## Development Application No DA2021/1812 for construction of two (2) storey dwelling-4 Munoora Street, Seaforth-Response to Objection submission

We have been engaged by GJ Gardner North to prepare a submission in response to the objection submission received from the owners of No. 50 Granview Street (adjoining southern property) to the above development application which seeks consent for the construction of a new two (2) storey dwelling. We make the following comments.

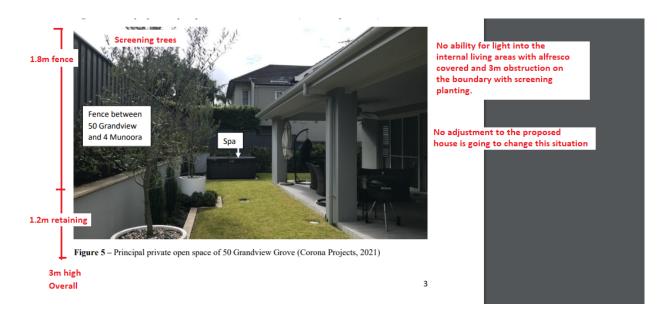
In the living habitable space of No.50 Grandview Street, there is no access to sunlight via the southern façade given the overshadowing impact of the 3m high fencing and retaining wall along with the fully covered alfresco roof. This is evident in the photograph above.

We would suggest that if the owners of No. 50 Grandview Street are serious about improving natural sunlight penetration into their habitable living area that skylights be installed to enable this to happen. Nothing in changing the existing plan of the proposed dwelling design will enable more solar access to penetrate the living habitable space of the dwelling.

Our client is willing to reduce the pitch of the roof from 20 degrees to 18 degrees in order to increase the solar access to the outdoor area. However, any amendment to the pitch is unlikely to affect the living area of the dwelling space and will only improve sunlight to the small outdoor area. We trust this is a sufficient compromise by our client.
